<b>Office Action Summary</b>	<b>Application No.</b> 10/569,942	<b>Applicant(s)</b> ENDO ET AL.	
	<b>Examiner</b> SEAHVOSH J. NIKMANESH	<b>Art Unit</b> 2812

### **DETAILED ACTION**

**FIG. 1**

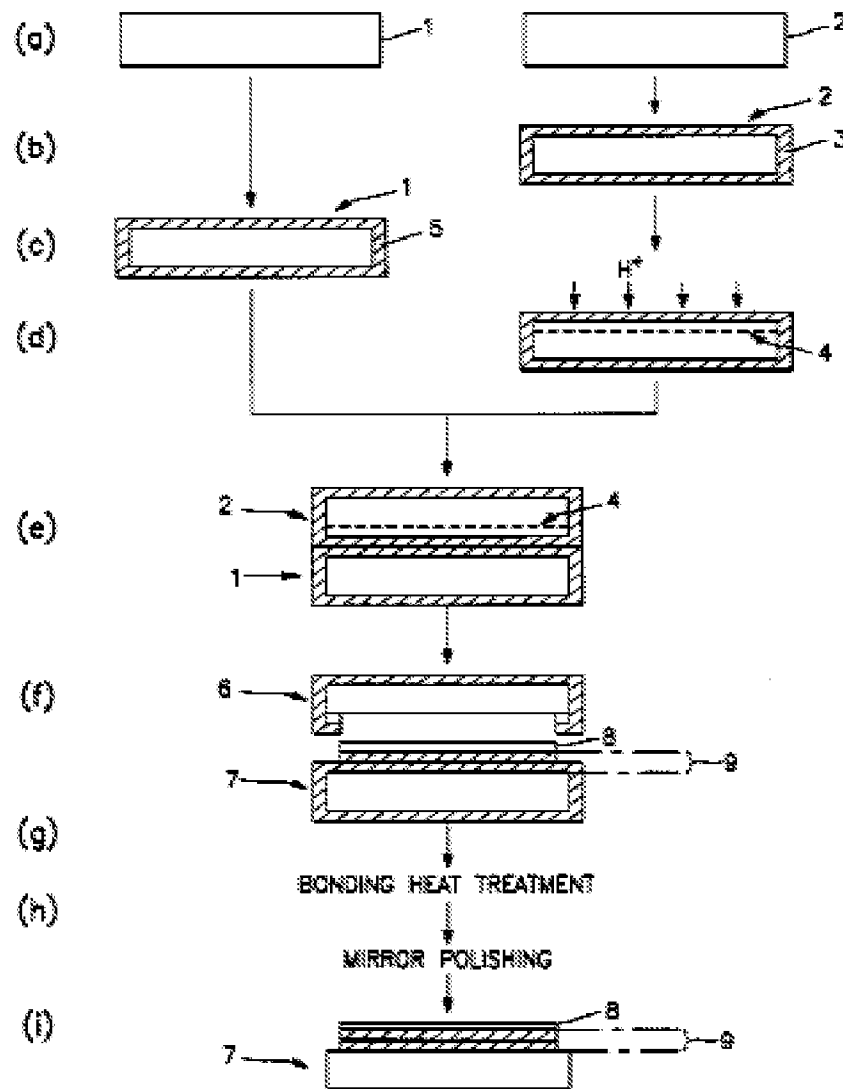
a. **Regarding claim 1**, Mitani et al. shows a method for manufacturing a bonded wafer, comprising the steps of:

ion-implanting of a light element into a wafer (2; step d; Column 6, lines 4-10; i.e. hydrogen ion or rare gas ion implantation) for active layer at a predetermined depth via an insulating film (3) that has been formed thereon to form an ion-implanted area (4) in said active layer wafer;

subsequently bonding (step e) said active layer wafer with a supporting wafer (1) having an insulating film formed thereon (5) together as their insulating films facing to each other to produce the bonded wafer (7); and

heat treating (step f) said bonded wafer to form bubbles (Column 6, lines 19-27) of said light element in said ion-implanted area and thereby induce a cleavage and separation of a part of said bonded wafer (8) defined in said ion-implanted side for forming an active layer wherein

the thickness of the oxide insulator is 50 nm and the thickness of the formed semiconductor layer is 400 nm (example 1).

Mitani et al. does not show that the thickness of said insulating film of said active layer wafer,  $t_{\text{dox}}$ , satisfies the following formula:

$t_{\text{dox}} < (1/9) \times t_{\text{soi}}$ , where  $t_{\text{soi}}$  = thickness of said active layer.

However, Mitani et al. discloses the same materials, ions, process steps, and features as the Applicant in the instant invention. These claims are prima facie obvious without showing that the claimed ranges achieve unexpected results relative to the prior art range. In re Woodruff, 16 USPQ2d 1935, 1937 (Fed. Cir. 1990). See also In re Huang, 40 USPQ 2d 1685, 1688 (Fed Cir. 1996) (claimed ranges of a results effective variable, which do not overlap the prior art ranges, are unpatentable unless they produce a new and unexpected result which is different in kind and not merely in degree from the results of the prior art). See also In re Boesch, 205 USPQ 215 (CCPA) (discovery of optimum value

Thus, it would have at least been obvious to one of ordinary skill in the art the time the invention was made to have used a tdox vs tsoi as specified in Mitani et al., with the motivation that the buried oxide can be formed having a desired thickness and still avoid the influence of the deviation in the thickness of the oxide film of the bond wafer on the thickness uniformity of the SOI layer (Column 3, lines 5-15). The combination can be met with a reasonable expectation for success since the claimed range is very near specified range in Mitani et al. and similar process steps are taken and similar materials are used.
